City of Seattle
Seattle Department of Transportation

MEMORANDUM
2011 February 02

Subject: **PORR Revision**
ADA Curb Ramp Installation Requirements

Figure 1. Crosswalks and Intersections as defined by Seattle Municipal Code

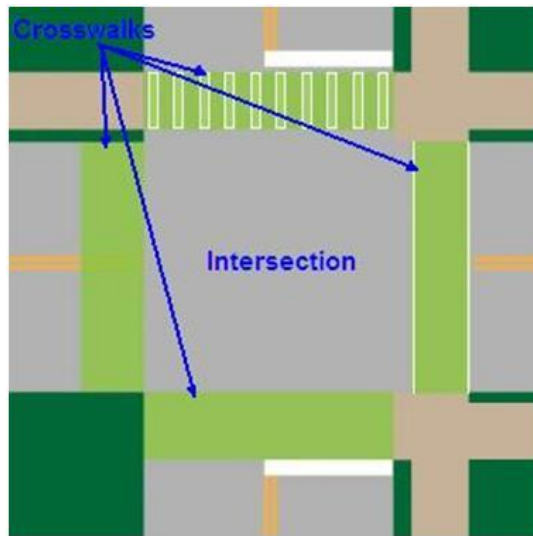
The crosswalk portion of the pedestrian pathway is defined in the Seattle Municipal Code and shown in Figure 1 below, along with the intersection area. Figure 2 shows the areas where a pavement opening would trigger curb ramp upgrades based on the ADA guidelines and the defined pedestrian pathway.

Any time the term "crosswalk" or "intersection" is used in the PORR, the definitions above should apply. Please note that a crosswalks exist regardless of markings.

SMC 11.14.135 Crosswalk.

"Crosswalk" means the portion of the roadway between the intersection area and the prolongation or connection of the farthest sidewalk line, or, in the event there are no constructed sidewalks, then between the intersection area and a line ten feet (10') therefrom, except as modified by a marked crosswalk. (RCW 46.04.160)

SMC 11.14.265 Intersection.

A. "Intersection" means the area enclosed within the projection of the lateral curbs, or if no curbs, then the projection of the lateral roadway boundaries of two (2) or more streets which join one another at an angle, whether or not such streets cross each other...

Figure 2. Pavement Openings Requiring upgrade of ADA Curb Ramps

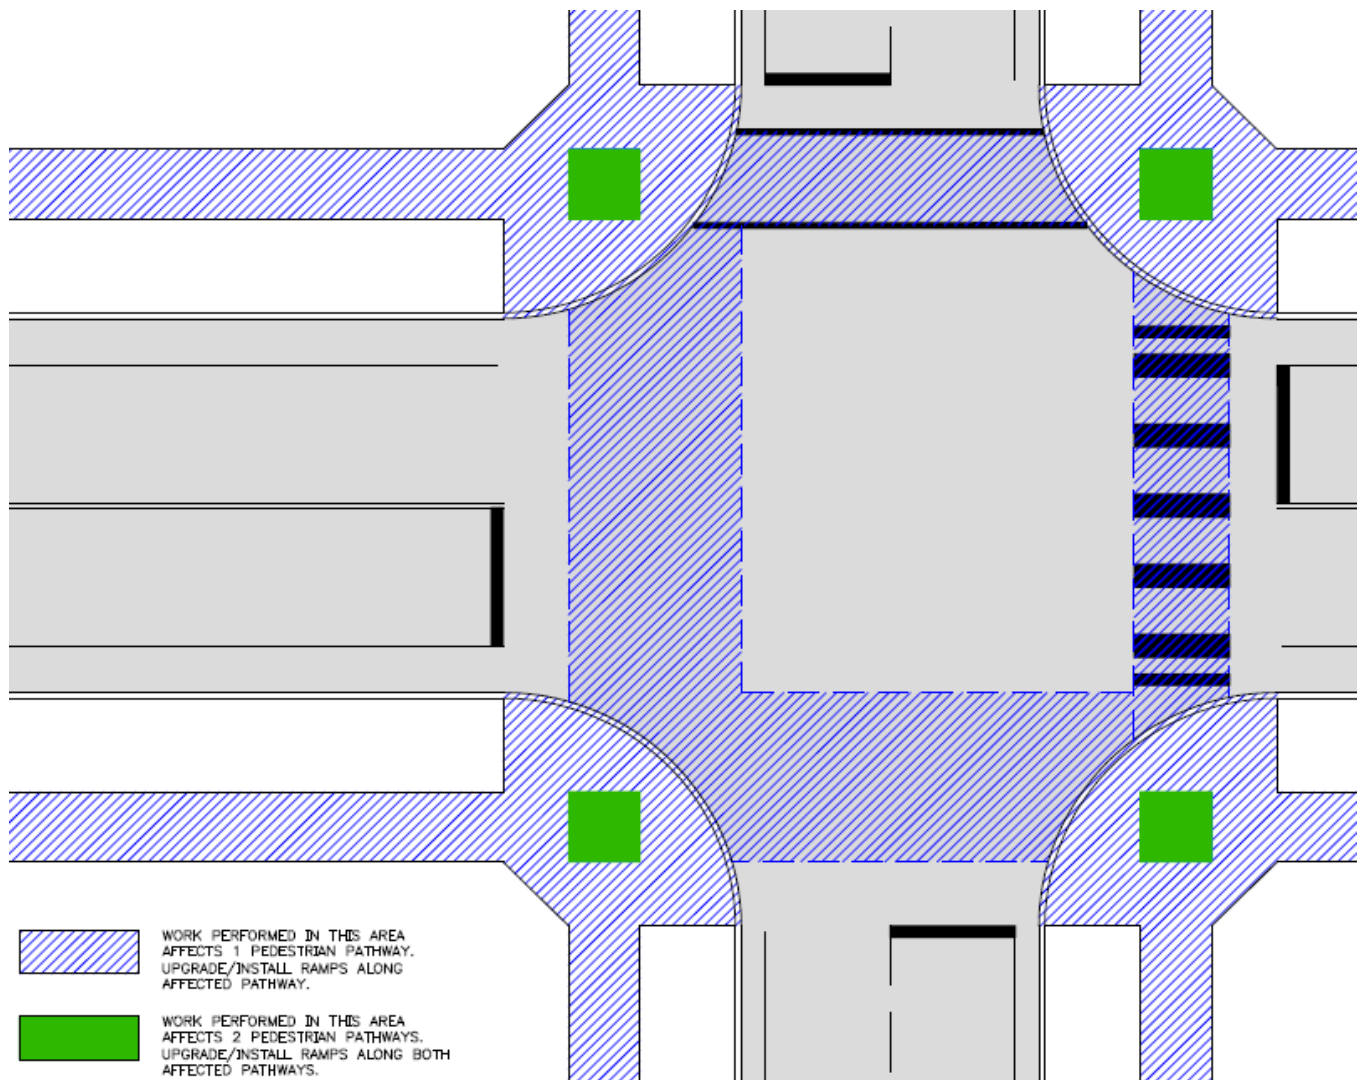
SDOT's Traffic and Roadway Design engineers have advised that any alterations to the pedestrian pathway (curb ramps, sidewalk, landing, marked or unmarked crosswalk, et al) will require installation of accessible curb ramps compliant with current ADA guidelines. In general replacement or retrofit of curb ramps will be necessary whenever a restoration:

- Involves any removal or construction activities within the crosswalk area
- Impacts curb ramps, sidewalks, landings, or curbs within the crosswalk or intersection area
- Affects access to or use of a public facility

The City of Seattle's Standard Specifications and Standard Plans for Road, Bridge and Municipal Construction are representative of the current ADA requirements. Reference Standard Plan Numbers 420 and 422 and Standard Specifications Section 8-14. Curb ramps must be addressed in pairs; if one ramp is built to current standard, its companion ramp must also be upgraded.
